**Working instruction No. 2 for TN 1000/31
Mounting brackets for fuel injection system**

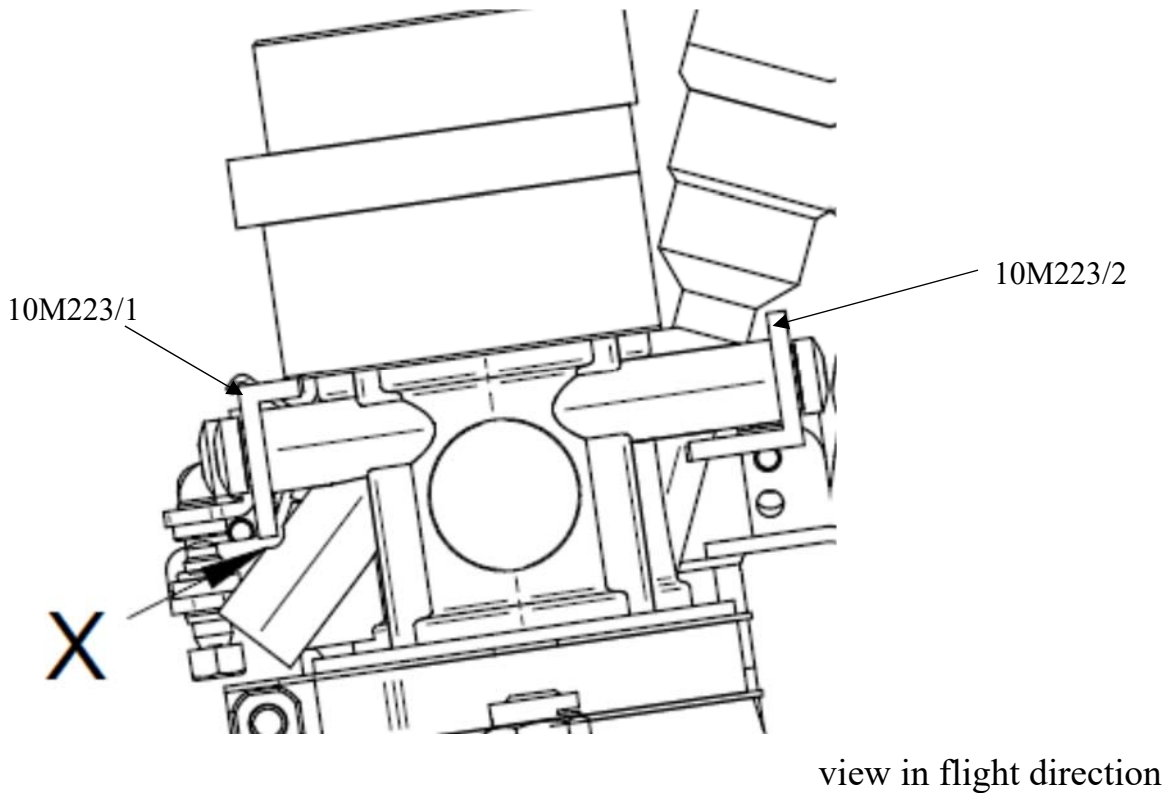
1. Remove the existing aluminium brackets.
2. Remove a small amount of material from the dummy sockets at both intake manifolds marked with X in the sketch below) to receive a clearance of approx. 1 mm between the intake manifolds and the new CFRP bracket 10M223/1.

3. Install the new CFRP brackets, secure bolts with Loctite 243..
4. Material:
